Report: TAB Report
Function: Test, Adjust, & Balance
Date: 07/09/2025
Completed By: National TAB

07-07-25 WAWA #8687 WILLIAMSBURG, VA

Project: 07-07-25 WAWA #8687 WILLIAMSBURG, VA

Asset: EF1

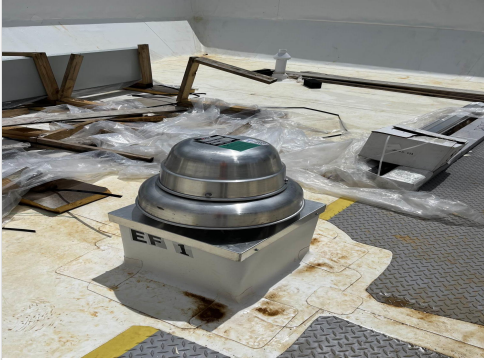
Issue Name : EF#1 is below design airflow
Description : Currently fan is at 255 CFM when design is at 300 CFM. Fan is already at max setting. Unable to balance within design airflow. Pressure in the duct was measured to be 0.17" which is enough pressure to be within design airflow. Speed controller is responding and is set at max. Recommended for manufacturer to review.

EF#1 IS NOT ABLE TO BE BALANCED WITHIN DESIGN AIRFLOW. NO DAMPERS ON EF#2 DUCTWORK TO BALANCE INDIVIDUAL DIFFUSERS

1 HVAC FLOOR PLAN
 M.S. 1/4" = 1'-0"

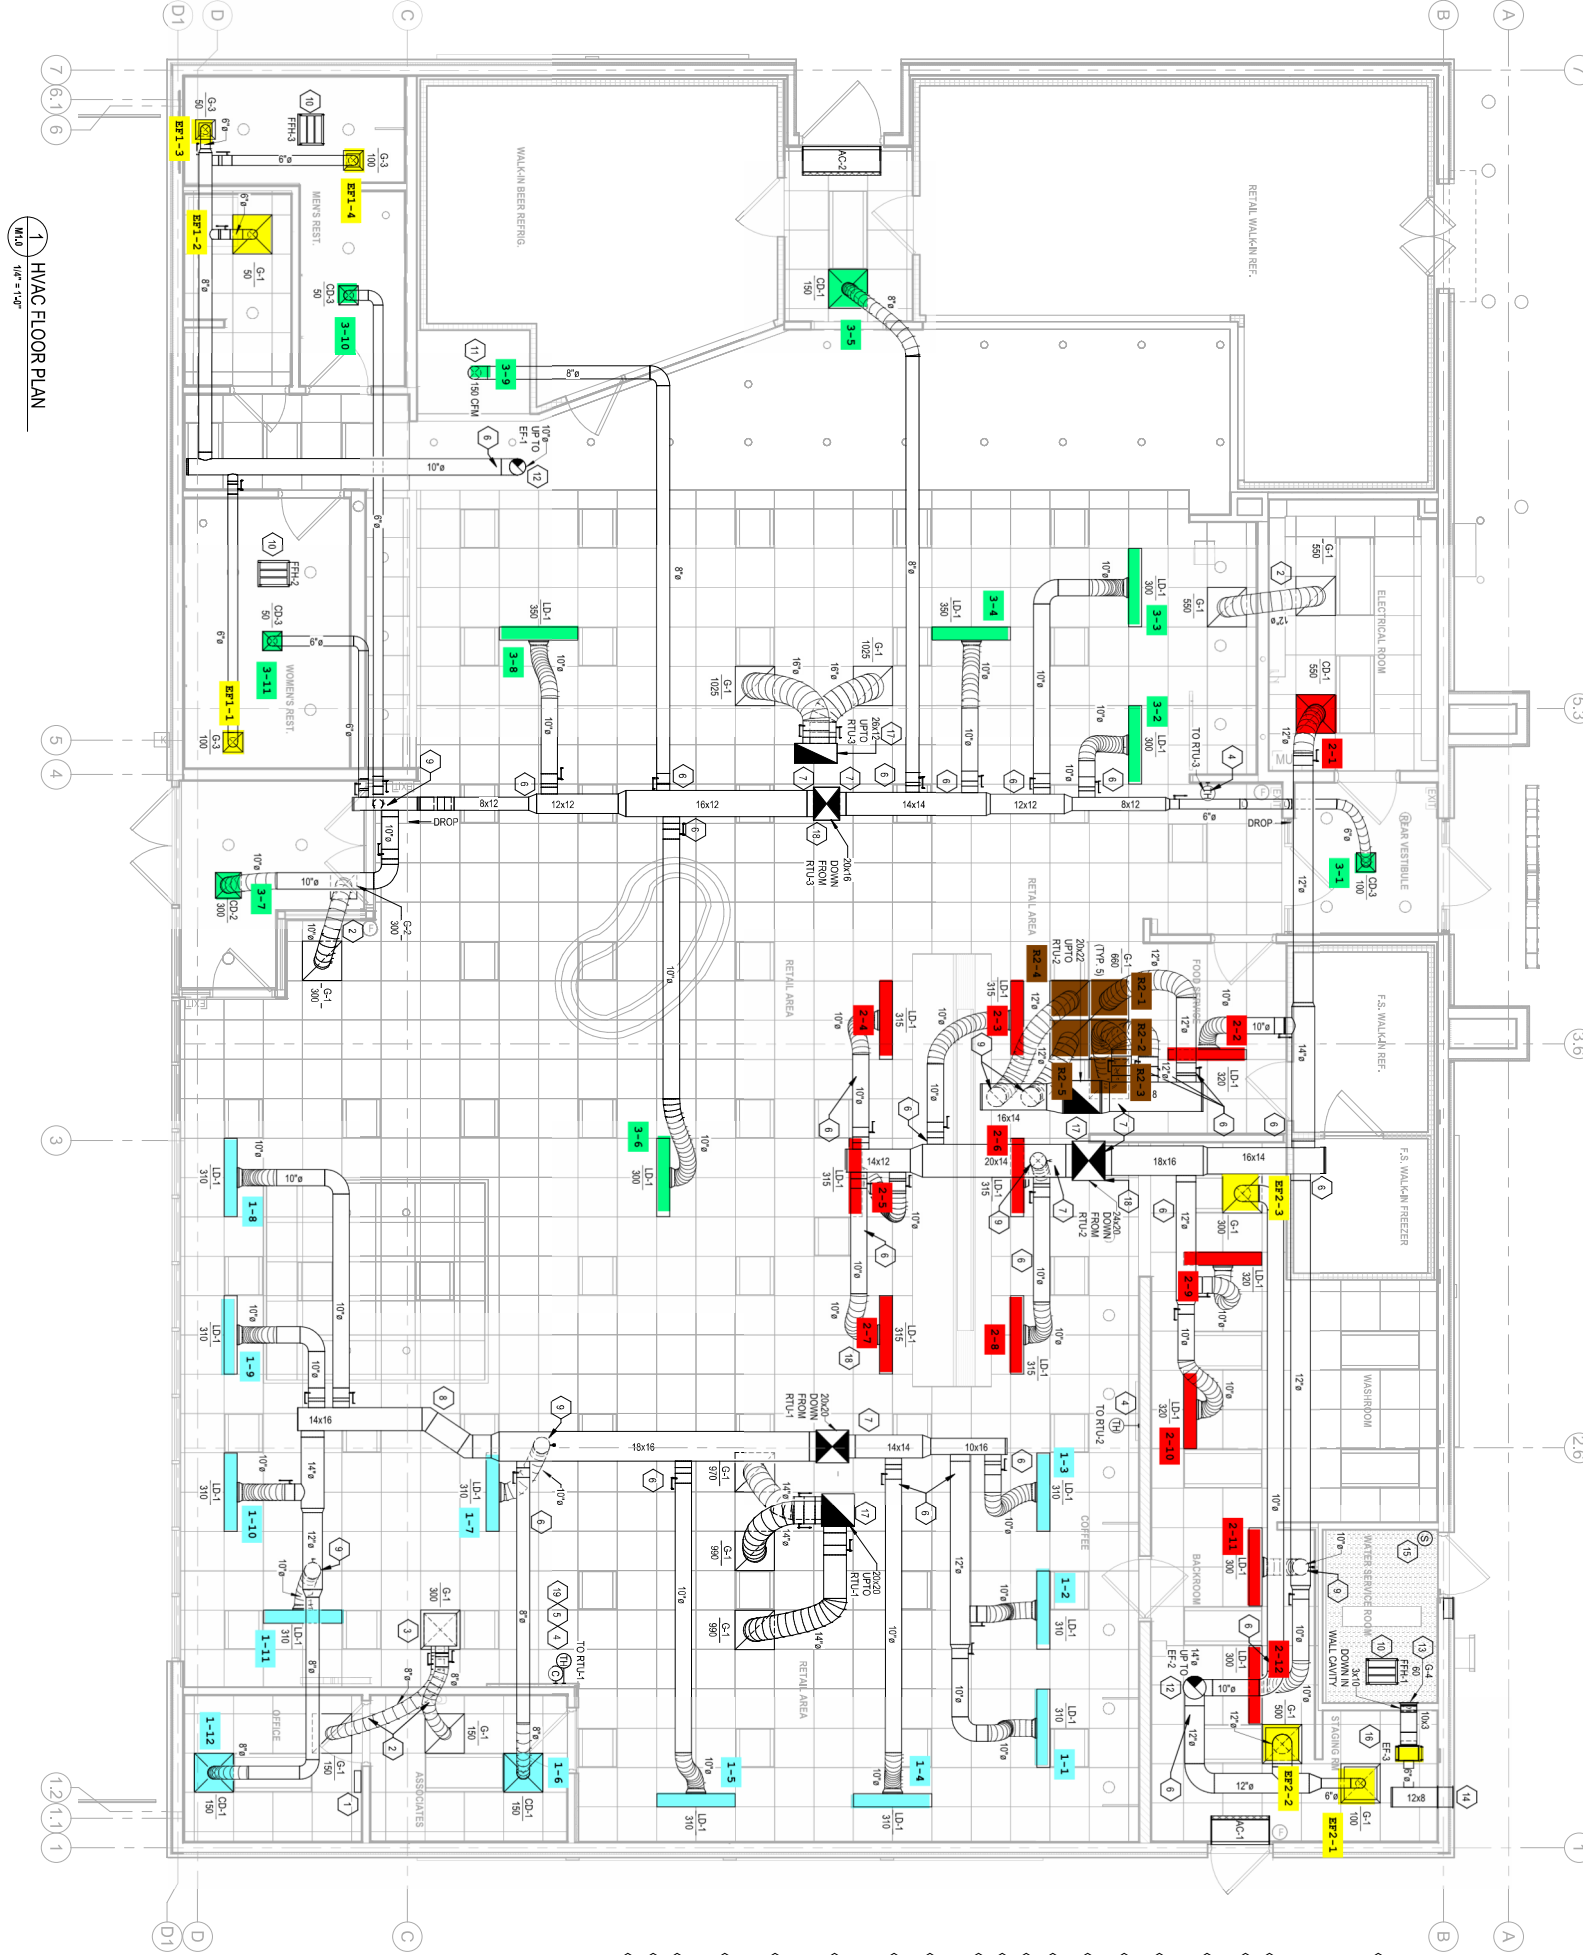
- Diffuser EF1-1 is not sealed with ceiling
- EF#1 is below design airflow
- EF#2 ductwork does not have dampers installed.
- Electrical Room diffusers need to be switched
- Gypsum Board not installed for diffuser 3-9
- Unable to turn off RTU#1 through diconnect

Issue Name : Gypsum Board not installed for diffuser 3-9
Description : As shown on M1.0 detail 11 it is stated that supply duct needs to be routed through gypsum board ceiling and into cavity above freezer. Seal duct around penetration air tight and to terminate duct with open end.
Created By : National TAB **Assigned To :** National TAB - Ian Fuller
Status : Open
Priority : Low **Asset Tag :**
Originated Date : 07/07/2025 - Ian Fuller - National TAB
